ADDENDUM NO. 05

Murrieta Mesa High School New Classroom Building – DSA 04-118451 MURRIETA VALLEY UNIFIED SCHOOL DISTRICT

Project No - 02132020
DSA No. - 04-118451

FINISH PLANS

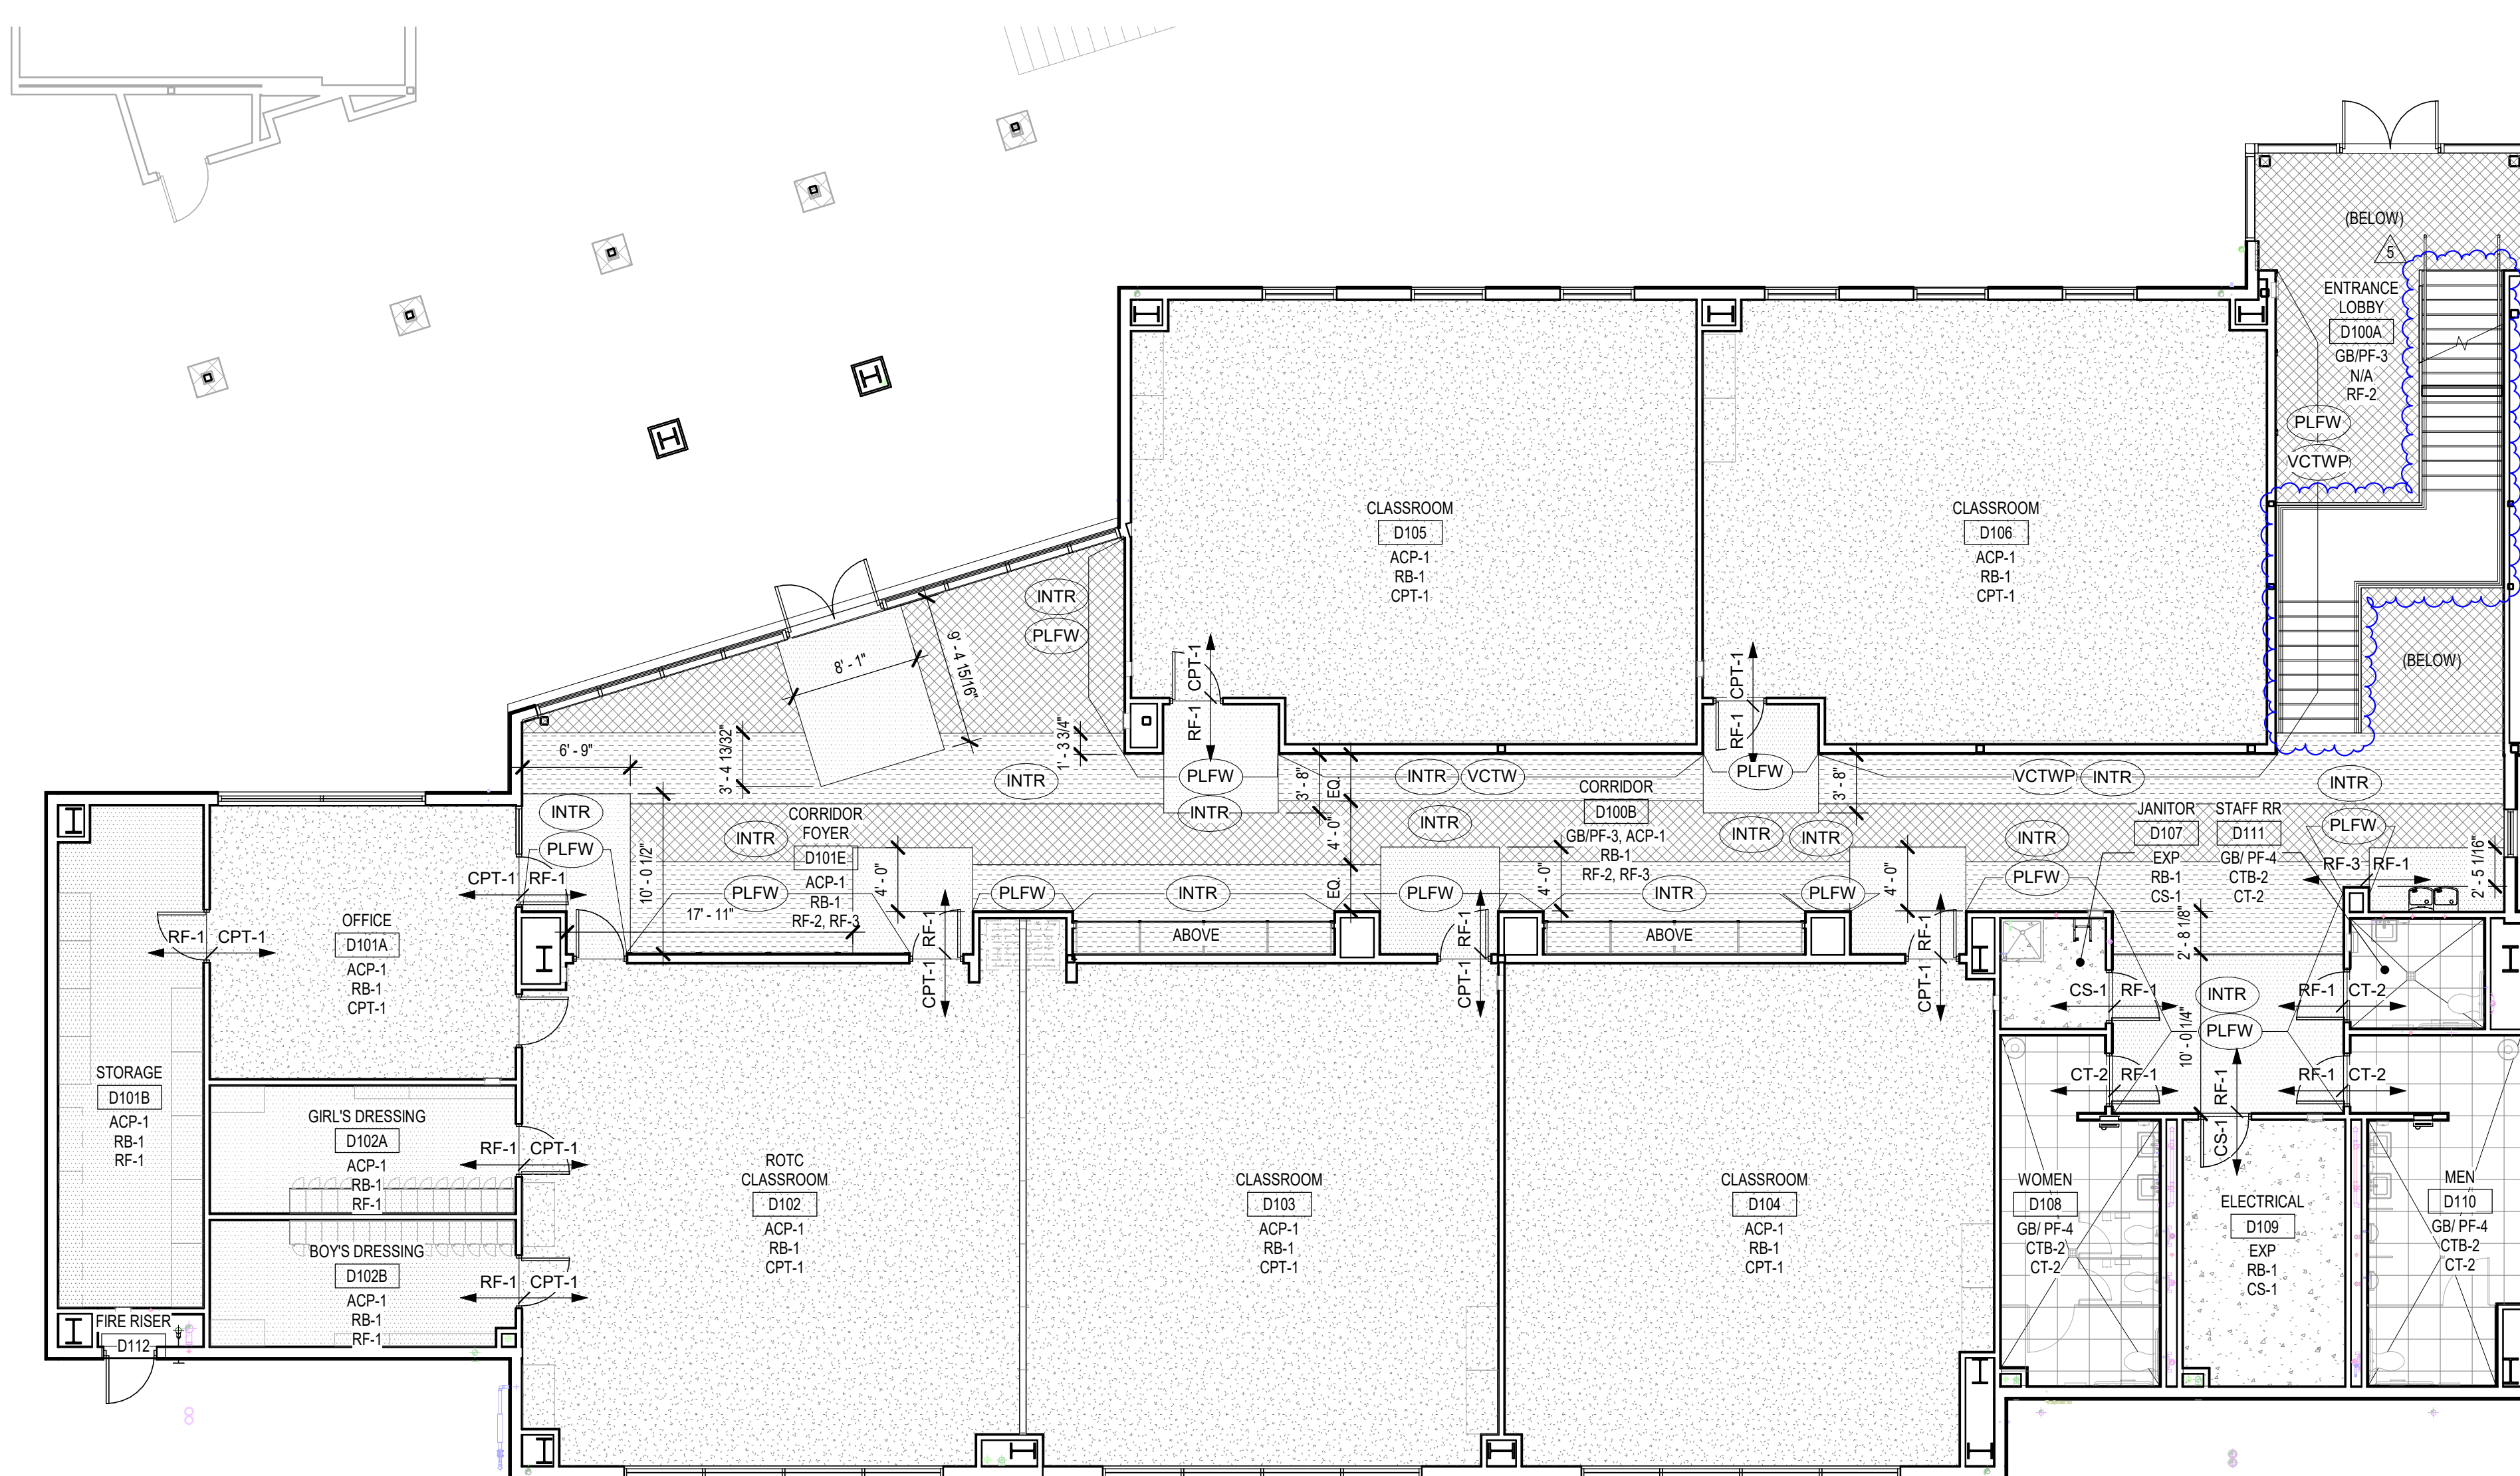
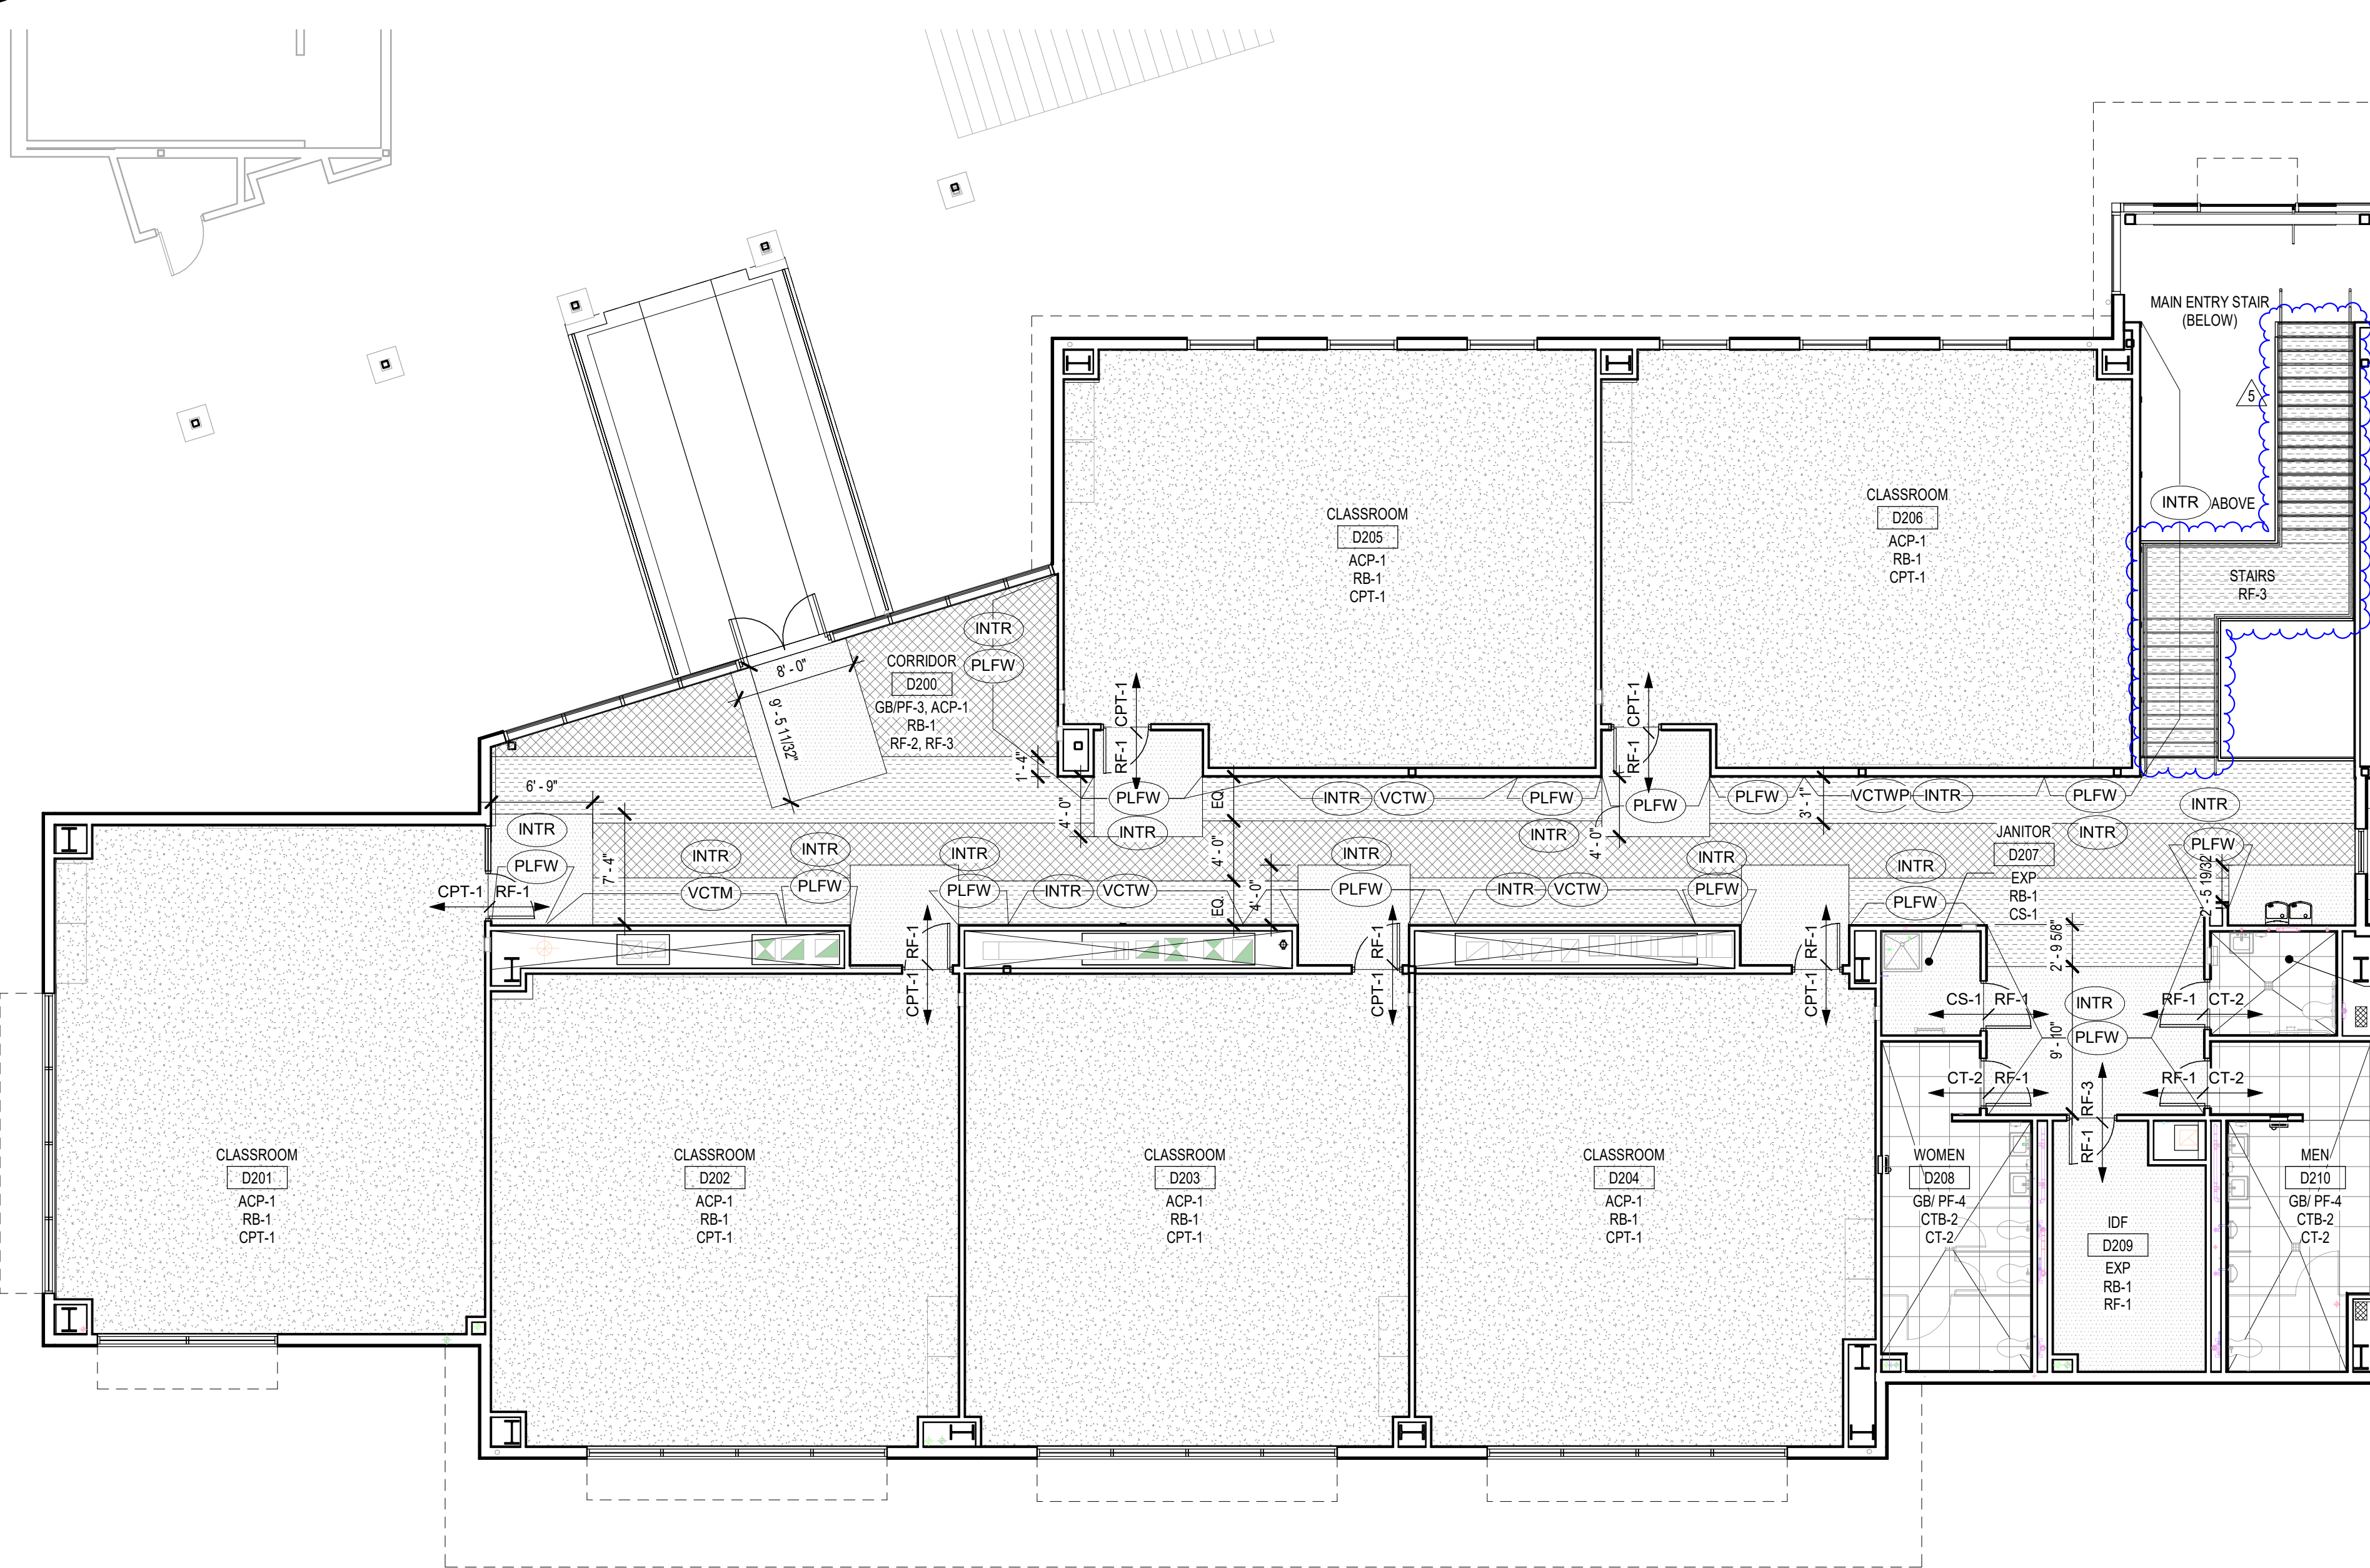
a. SHEET NO. A8.3

Revise currently issued drawing per AD5-A14.
